**AGENDA ITEM SUMMARY / STAFF REPORT**  
**FLORENCE CITY COUNCIL**

**ITEM TITLE:** *Resolution PC 23 09 DR 03*  
Three Mile Prairie Partial Design Review to Interpret the Use of a 12" x 6'  
*Continuous Concrete Footing* to Meet the Shared and Common Foundation  
Element in the Definition of an Attached Single-Family Dwelling

**RESOLUTION PC 23 09 DR 03**

**Public Hearing Dates:** July 25, 2023 & August 22, 2023 **Assistant Planner:** Clare Kurth  
**Date of Report:** August 15, 2023  
**Application:** PC 23 09 DR 03 – 3 Mile Prairie House Design Modification

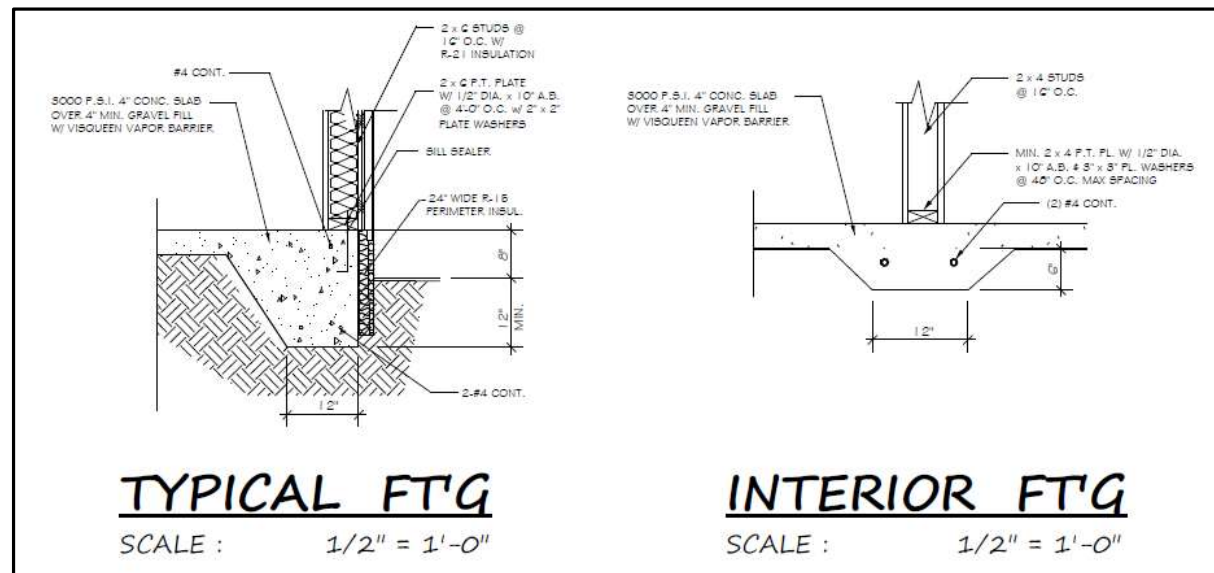
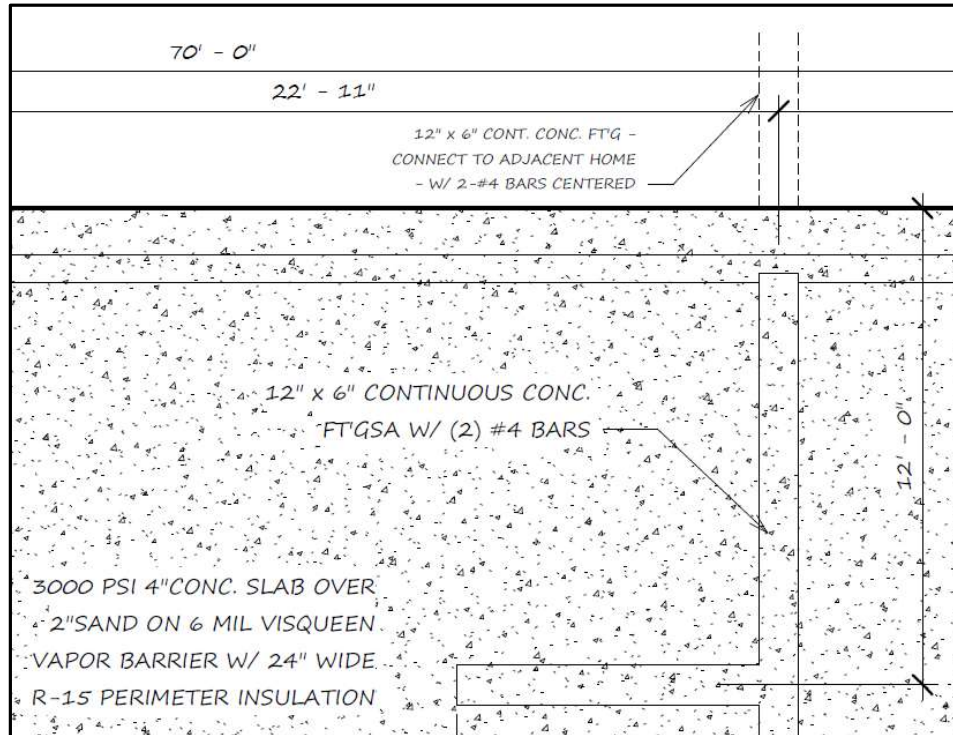
Comment:	<p>The home design illustrates the houses being connected by a 12" x 6" <i>continuous concrete footing</i>. The foundation plan illustrates the connecting footing abutting the slab. The structural footing from the dwelling does not connect to the proposed connecting footing. The Planning Commission is being tasked with determining if the proposed "attachment" meets the intent of the code for being attached by the foundation.</p> <p>This home design does not include attachments of a roof, common wall, or foundation beyond the footing.</p> <p>The 2021 Oregon Residential Specialty Code adopted by the Oregon Building Code division does not have a definition for <i>attached dwelling</i>, but OAR 660-008-005 does define attached single family housing and will be included later in these Findings.</p> <p>The Planning Commission is being tasked with <del>two</del><u>three</u> main questions.</p> <ol style="list-style-type: none"> <li>1. Does the 12"x6" continuous footing meet the definition of foundation?</li> <li><u>2. Does the 12"x6" continuous footing meet the intent of the code for the units being attached?</u></li> <li><u>3. Do the two dwelling units share a common foundation?</u></li> </ol> <p><u>*Please see continued discussion on attached and detached dwelling definitions under OAR 660-008-0005.</u></p>

The submitted site plan indicates a 12"x6" *continuous concrete footing* to connect to adjacent home as the proposed attachment for these units to be defined as attached single family dwelling units. The *continuous concrete footing* may partially meet the 7b. definition of a footing as it is *the part of the bottom of a structure that is in contact with the soil or rock foundation*. However, the 12"x6" *continuous concrete footing* does not meet the definition of a footing when using 7a. as the footing is not the substructure or bottom unit of a wall or column nor does the footing meet section 7c. that reads; *an enlargement at the lower end of a foundation wall ... to distribute the load*.

Conclusion: The proposed materials that create physical contact between adjacent dwelling units may meet the definition of a footing as it is in contact with the dwelling units' individual foundations and may be able to be considered an enlargement at the end of the foundation wall. However, the structure does not meet the definition of footing when considering the statement *to distribute load*. Exhibit D supplies information on the load that the footing is supporting in the form of sand and rain loads. These loads will be discussed in more detail later in this section.

The definition of foundation includes language for providing a base of support and a means of transferring building loads to the soil below. No engineering plans were submitted to demonstrate the 12"x6" *continuous concrete footing* is designed to transfer building loads or offer support to the building. This 12"x6" *continuous concrete footing* does not meet the definition of a foundation.

The proposed footing may be a portion of the foundation (although the plans do not illustrate this rather a connection), but it is not the foundation. Therefore, these units are not attached by a shared foundation.
